Drawing Change Notice

CHANGE DOCUMENT NO.
24590-PTF-VDCN-MS-10-00008

JOB NO.	TITLE FOR CHANGE NOTICE
24590	UFP-VSL-00062B Redesign

JUSTIFICATION FOR CHANGE	CAUSE CODE
Based on the re-analysis of UFP-VSL-00062B, per calculation 24590-PTF-MVC-UFP-00023, for revised seismic conditions and design evolution, required a redesign of the vessel.	01 and 23

ELEVATION

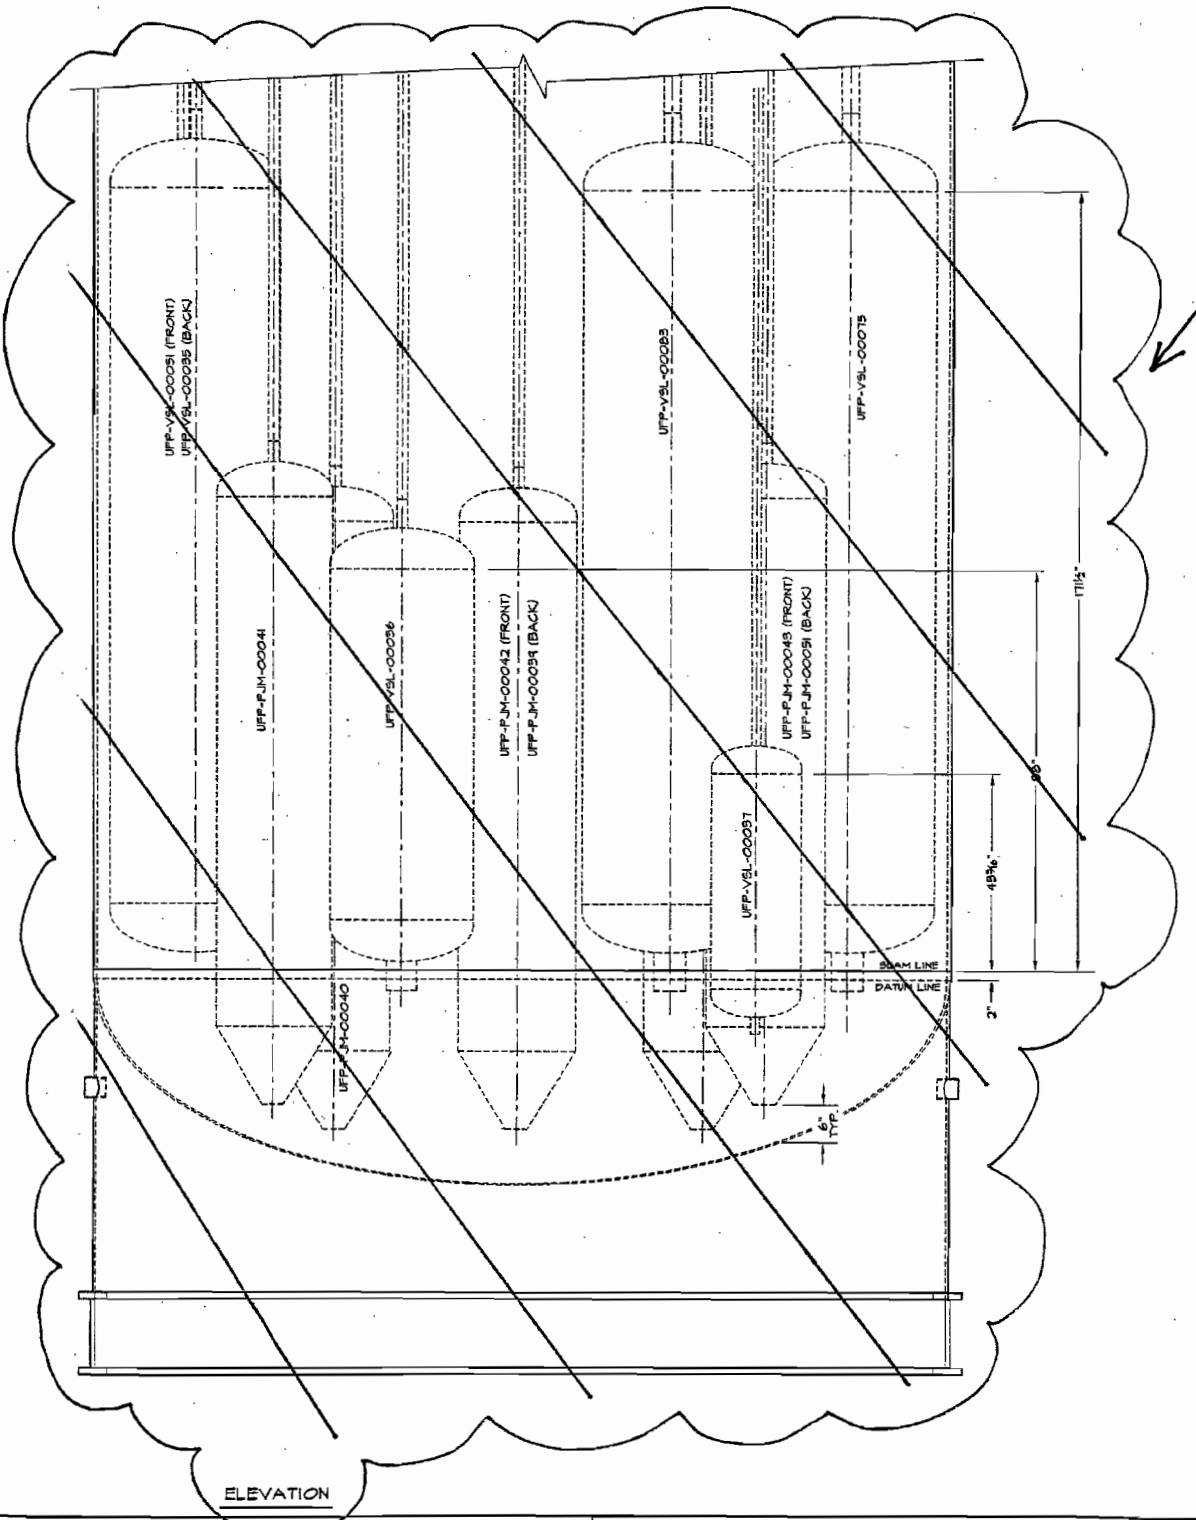
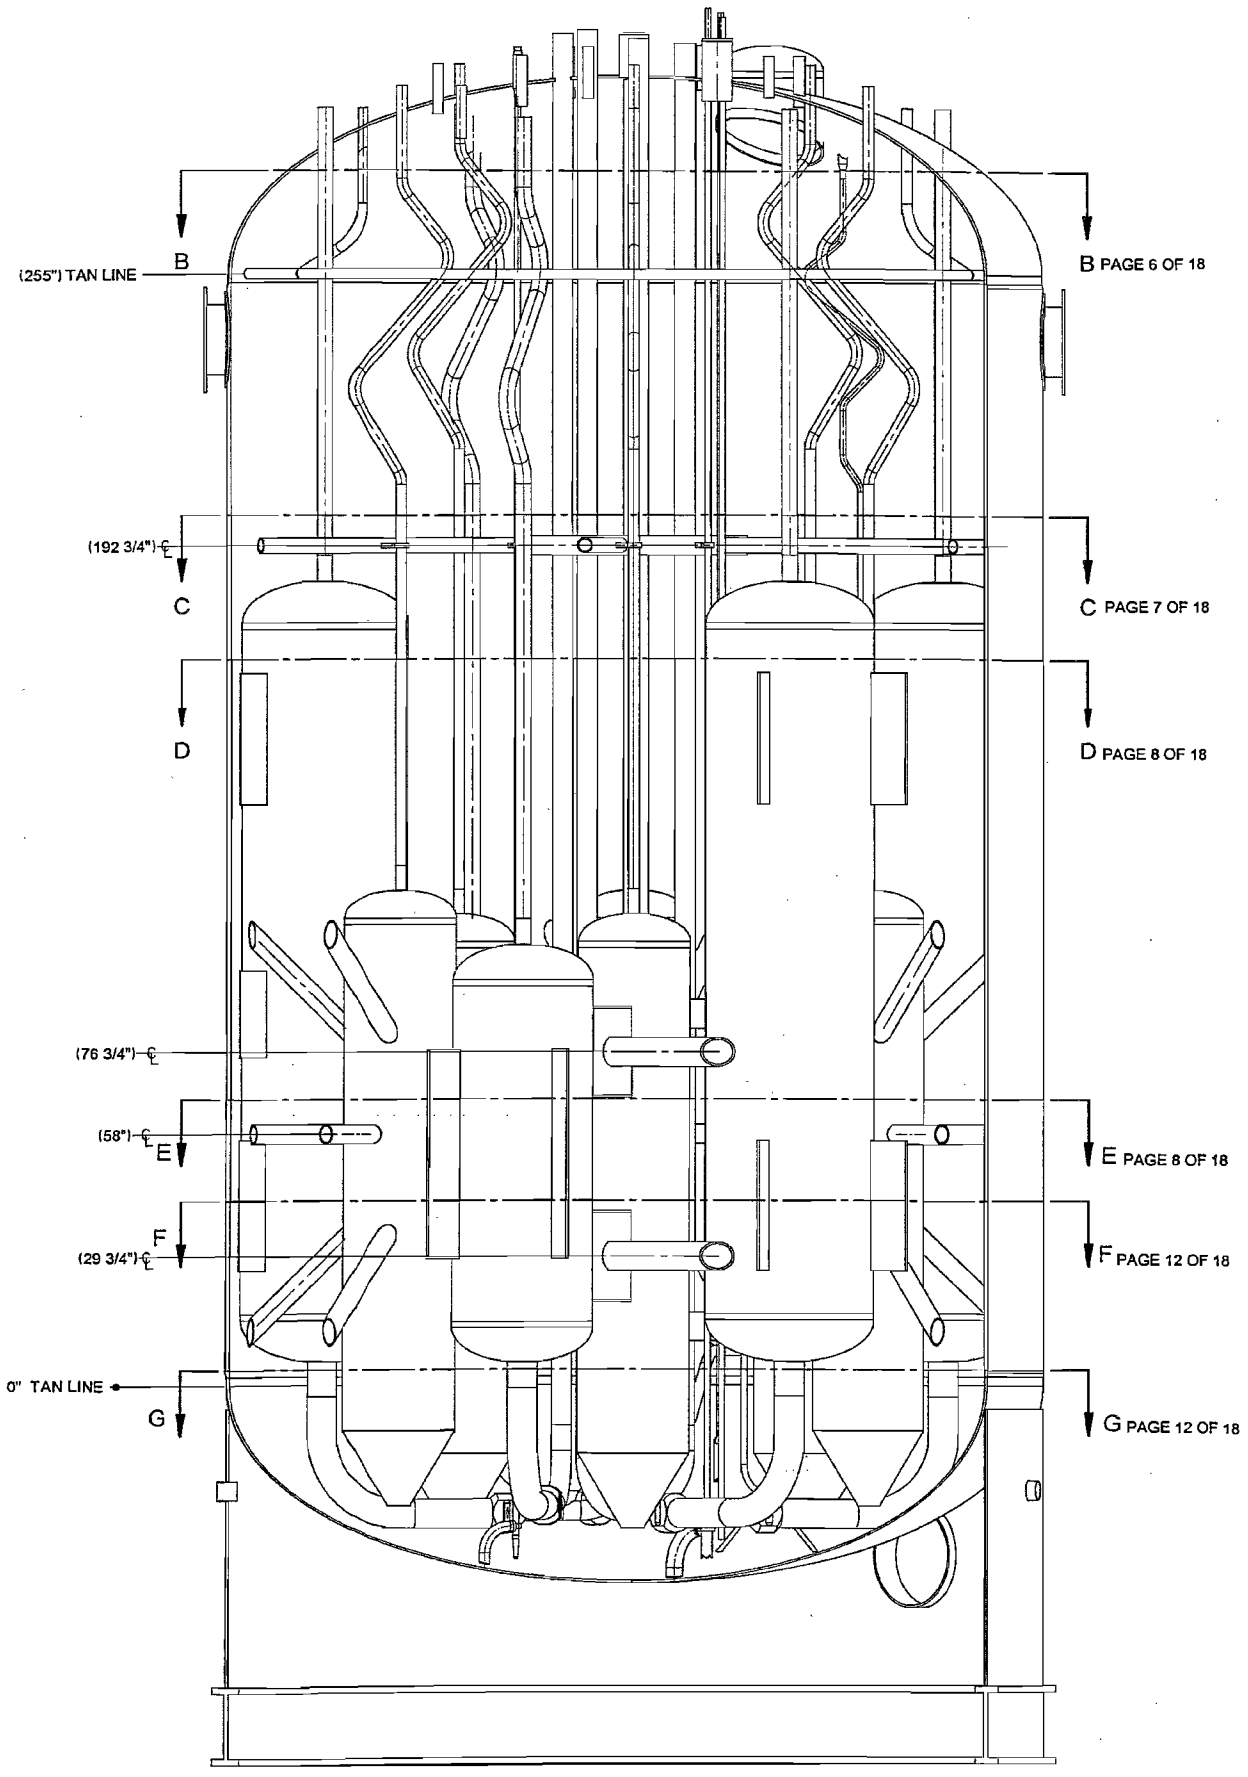
a.) Elevation View: Delete Elevation View and replace with NORTH ELEVATION VIEW shown on Attachment 1, page 5 of this VDCN.

DELETED BY RPP-WTP

INTERNAL VESSEL SUPPORT ORIENTATION
SCALE: ⅜" = 1'-0"

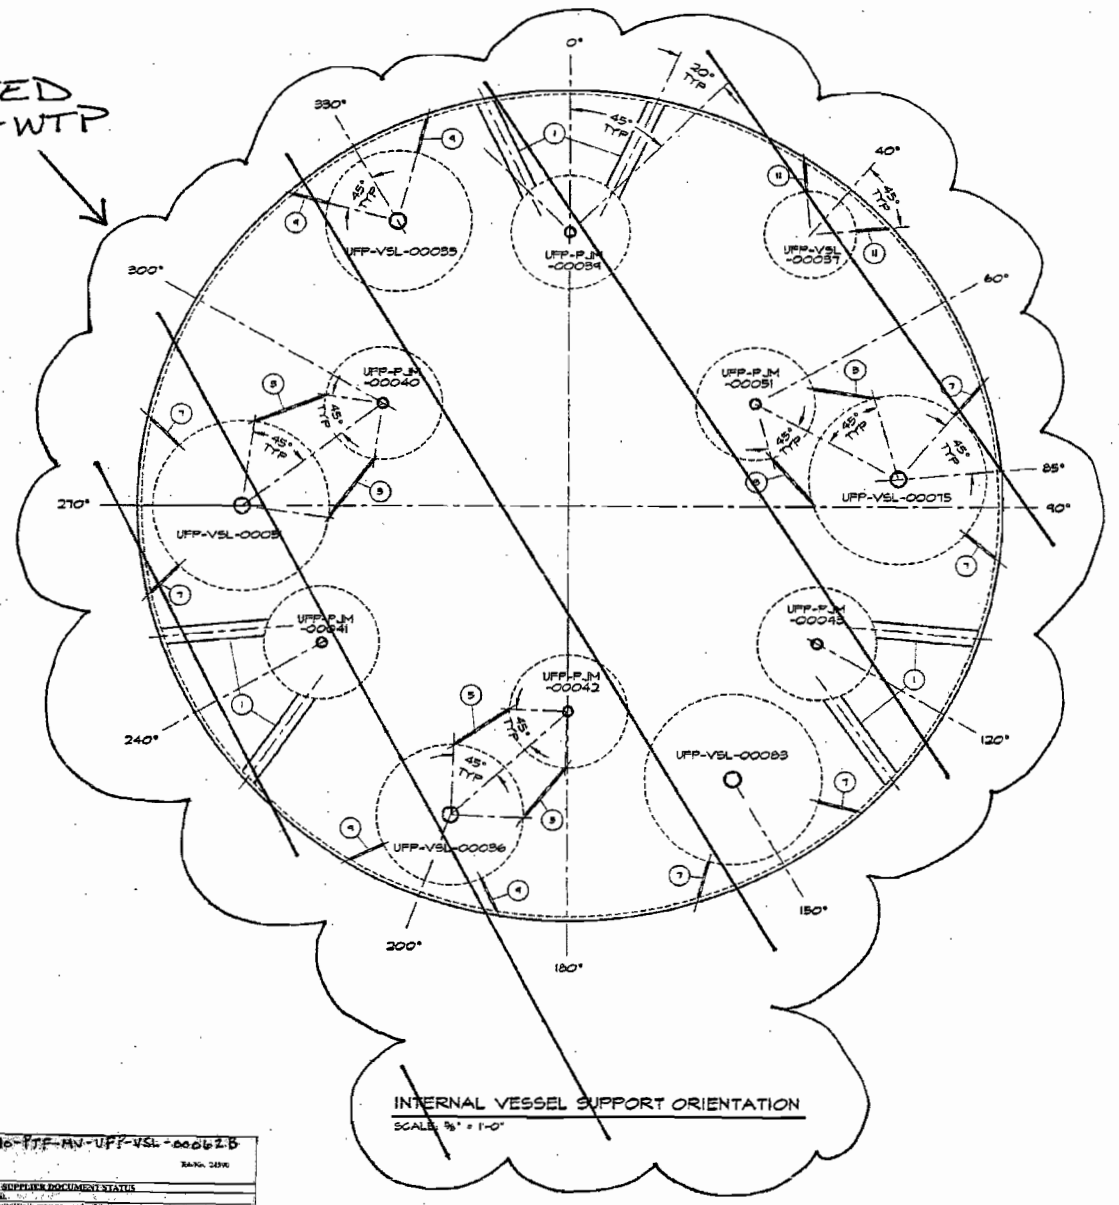
b.) Internal Vessel Support Orientation: Remove view as this will be covered in Sections B-B, C-C, D-D, E-E, F-F, and G-G shown on Attachment 1, page 5 of this VDCN.

SECTION B-B
SCALE: 1/16

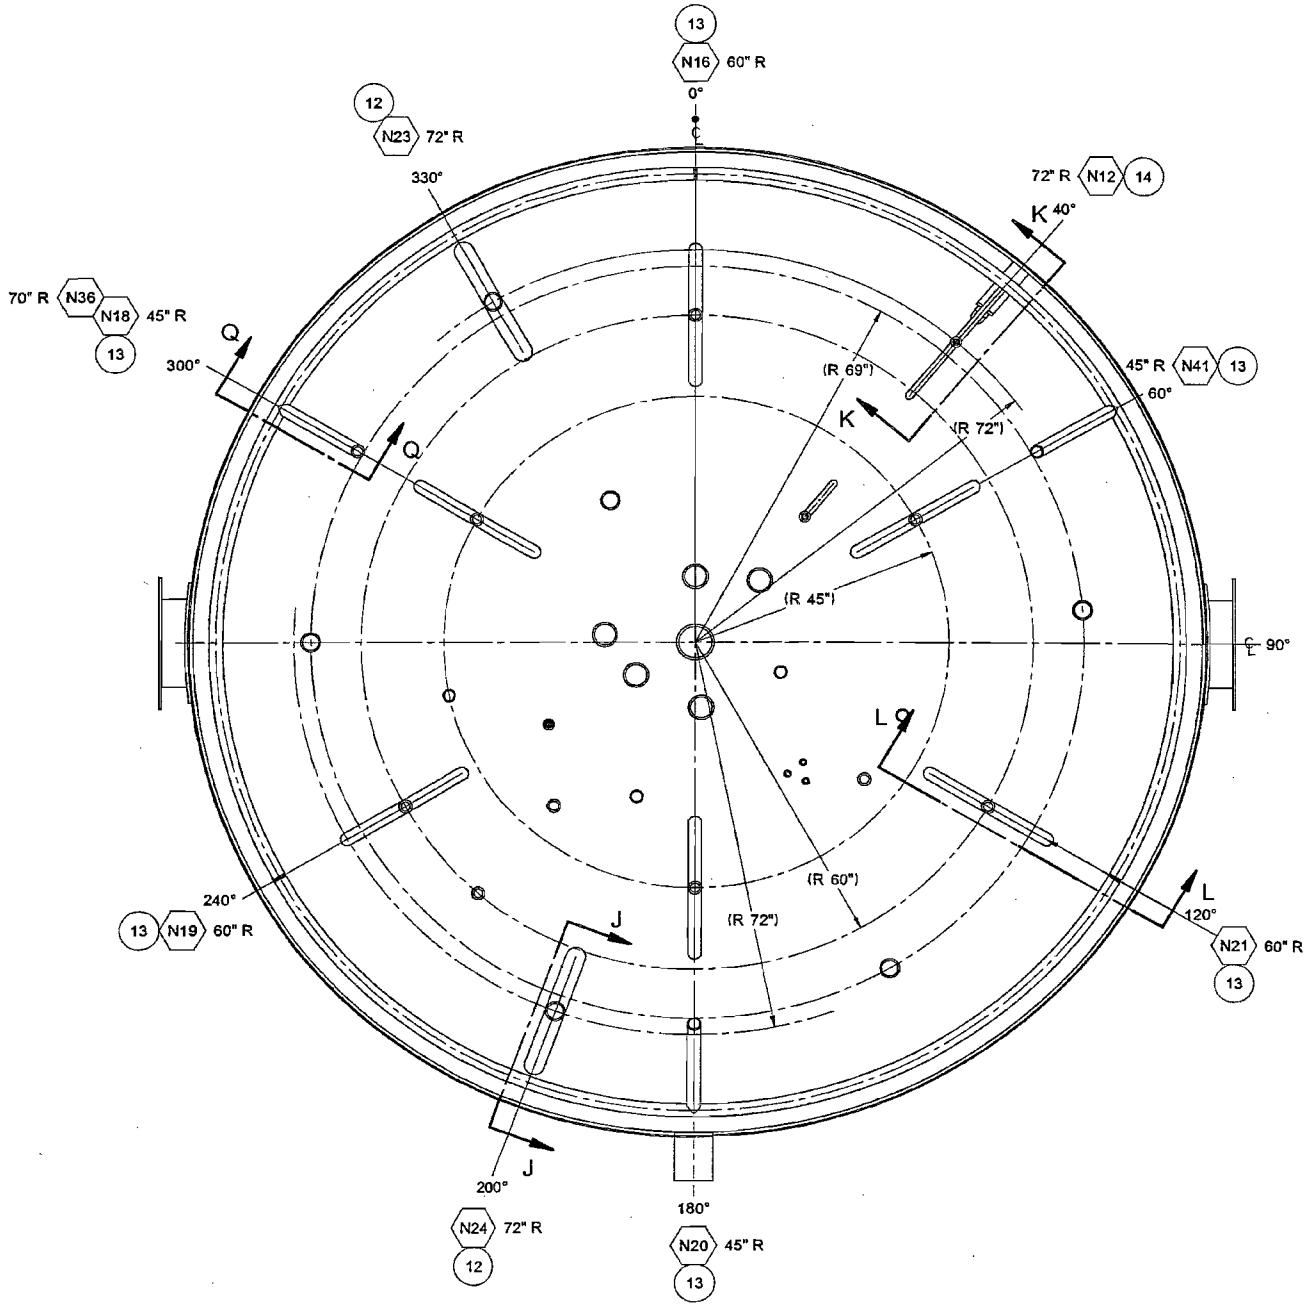
d.) Add SECTION B-B shown on Attachment 1, page 6 of this VDCN.

13 SECTION L-L
THERMAL EXPANSION S-BEND
SCALE: 1/10

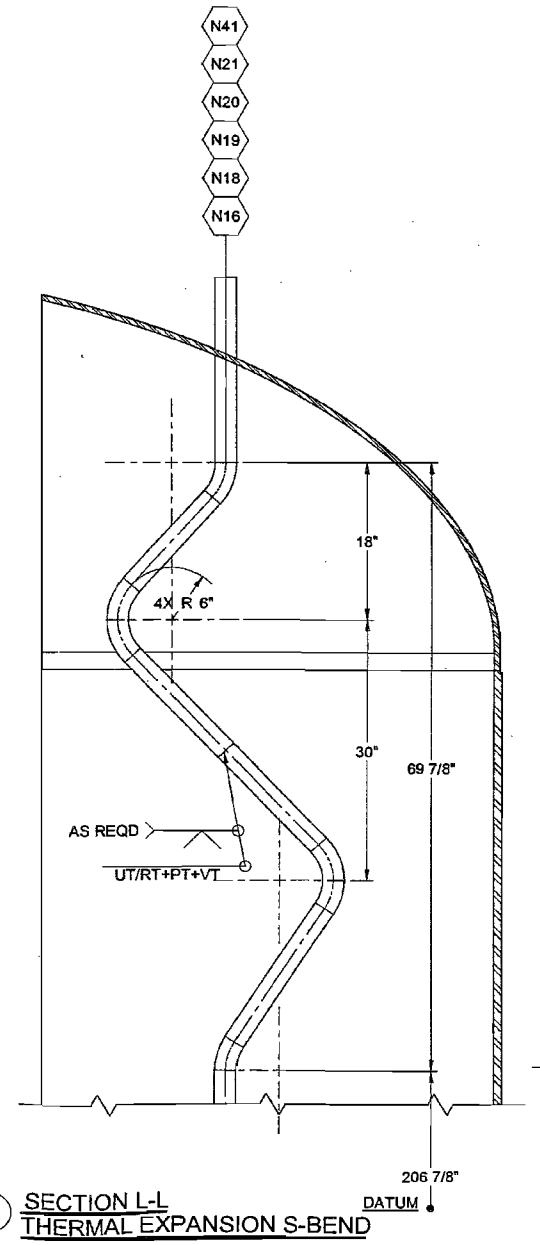
g.) Add SECTION L-L and item 13 THERMAL EXPANSION S-BEND shown on Attachment 1, page 6 of this VDCN.

14 SECTION K-K
THERMAL EXPANSION S-BEND
SCALE: 1/10

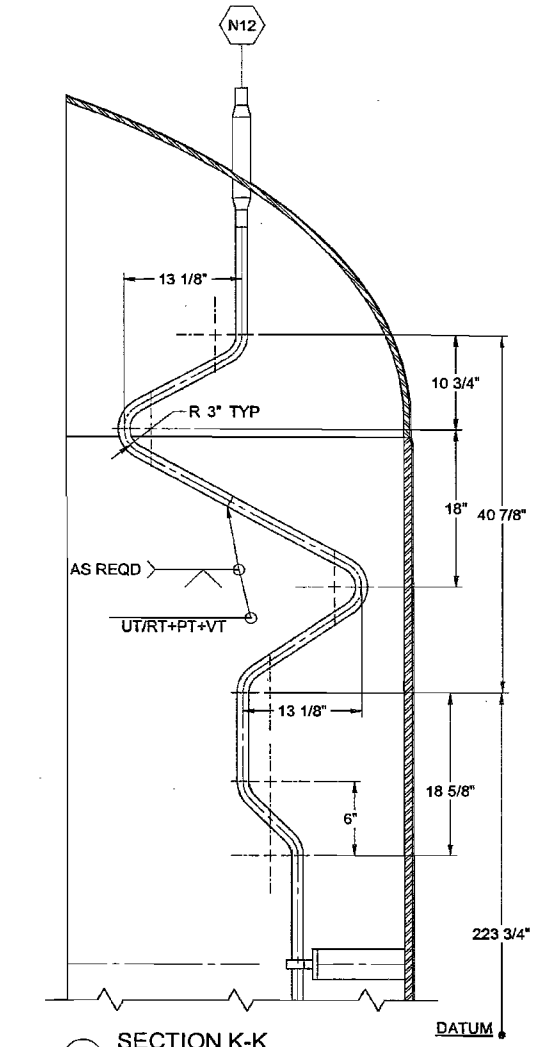
f.) Add SECTION K-K and item 14 THERMAL EXPANSION S-BEND shown on Attachment 1, page 6 of this VDCN.

12 SECTION J-J
THERMAL EXPANSION S-BEND
SCALE: 1/10

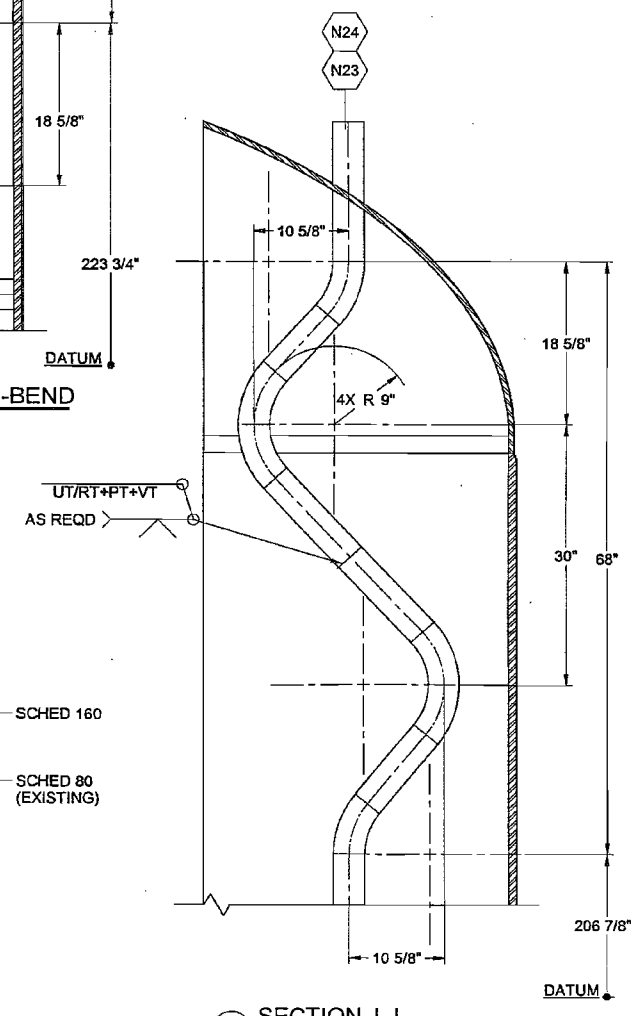
e.) Add SECTION J-J and item 12 THERMAL EXPANSION S-BEND shown on Attachment 1, page 6 of this VDCN.

SECTION C-C
SCALE: 1/16

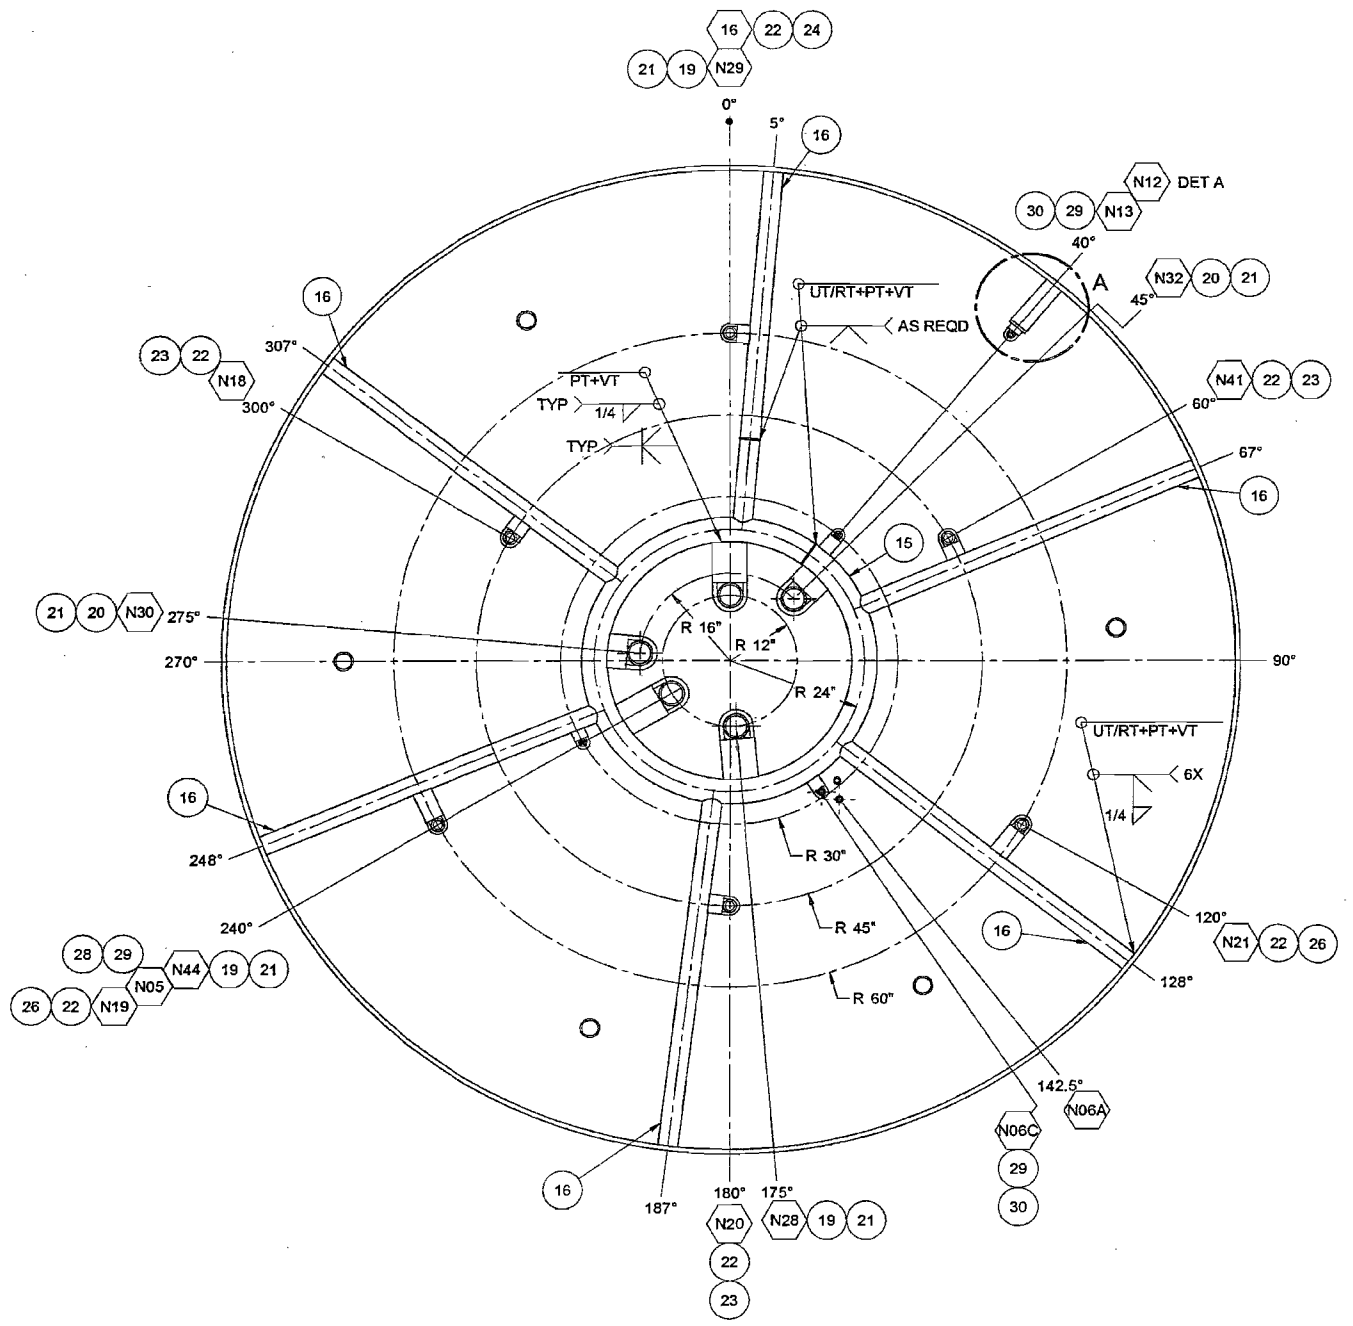
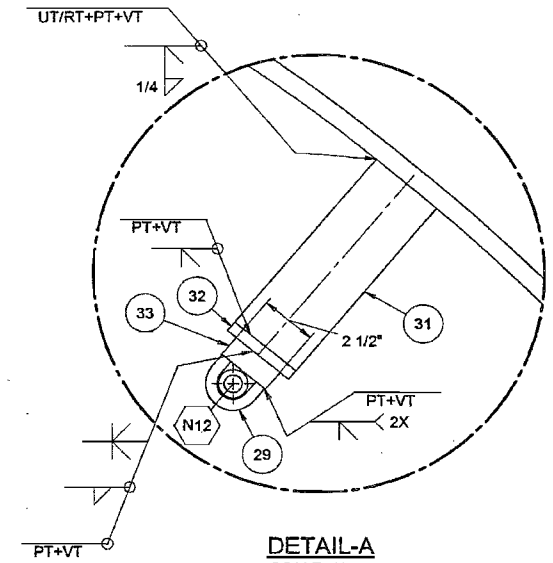
h.) Shown on Attachment 1, page 7 of this VDCN, add the following:

(1.) SECTION C-C

(2.) DETAIL-A

1. GUIDE RINGS ARE WELDED AFTER CORRECTLY POSITIONING THE GUIDE RING SUPPORTS. GUIDE RINGS SHALL MAINTAIN .125 DIAMETRAL CLEARANCE WITH PIPE.
